# MSR Pocket Rocket Gas Stove

## Potential Fire Hazard

### Limited Product Safety Recall

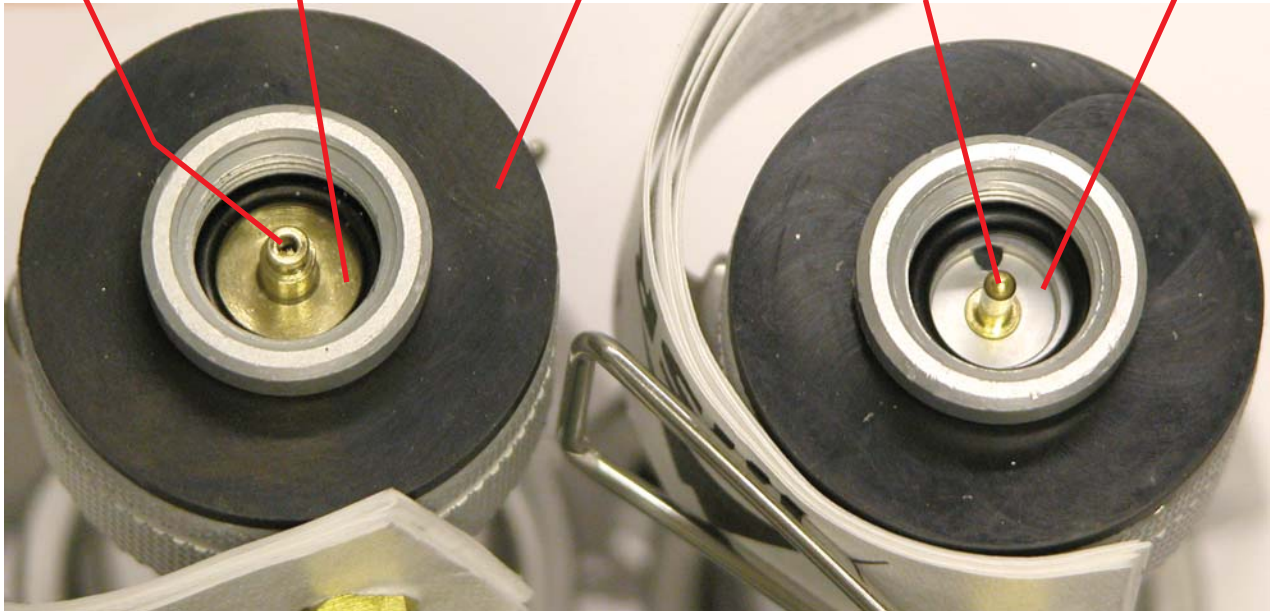
#### DEFECTIVE

Batch Number under black rubber seal is **KCL05**.

- **Gold coloured base** AND
- **Hollow Pin**

Very recently, one of MSR's suppliers made an unauthorized change to the actuator pin of the MSR Pocket Rocket stove. The actuator pin allows the gas to flow out of a gas canister once the stove is attached. The defective actuator pin may lead to a gas leak during installation/removal of the stove to/from the gas canister. In the presence of an ignition source, during installation/removal, there is a possibility of a fire hazard and associated injury.

#### CORRECT

- **Silver OR Gold coloured base**
- **Solid Pin**
